UNITED STATES PATENT AND TRADEMARK OFFICE

APPLICATION NO.	FILING DATE	FIRST NAMED INVENTOR	ATTORNEY DOCKET NO.	CONFIRMATION NO.
10/711,289	09/08/2004	Robert G. Coulombe	GTAP:102US	5288

Office Action Summary	Application No. 10/711,289	Applicant(s) COULOMBE ET AL.	
	Examiner Marcus Menezes	Art Unit 3677

DETAILED ACTION

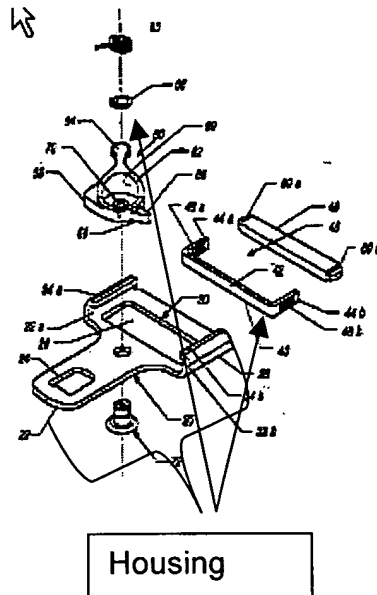
2. Claims 1-3 and 6-17 rejected under 35 U.S.C. 102(b) as being clearly anticipated by Ashline et al. (US Patent No. 5,649,341, hereinafter "Ashline").

Ashline discloses a quick release buckle comprising a first cam (62); a knurl bar (48); and a first spring (80) engaged with said first cam and said knurl bar. (See Fig. 1 below). Ashline further discloses that said first spring is operatively arranged to apply compressive force against said first cam and said knurl bar. (See Figs. 2-3 and col. 2, lines 60-67). Also, said knurl bar is operatively arranged to grip a belt (90) in response to said compressive force. Moreover, a housing with an integral mounting structure (72) is disclosed; and wherein said first cam is operatively arranged to rotate about said mounting structure and wherein said housing further comprises first (20) and second (65) components and said mounting structure is integral to said first component. (See figure below). Additionally, said mounting structure is integral with said second component, is extruded from said housing and is operatively arranged to engage said first and second components.

Furthermore, Ashline discloses that said housing has a first mounting structure that is a protrusion fixedly attached to said housing and where a first cam pivotally mounted on said first mounting structure is operatively arranged to rotate about said first mounting structure.
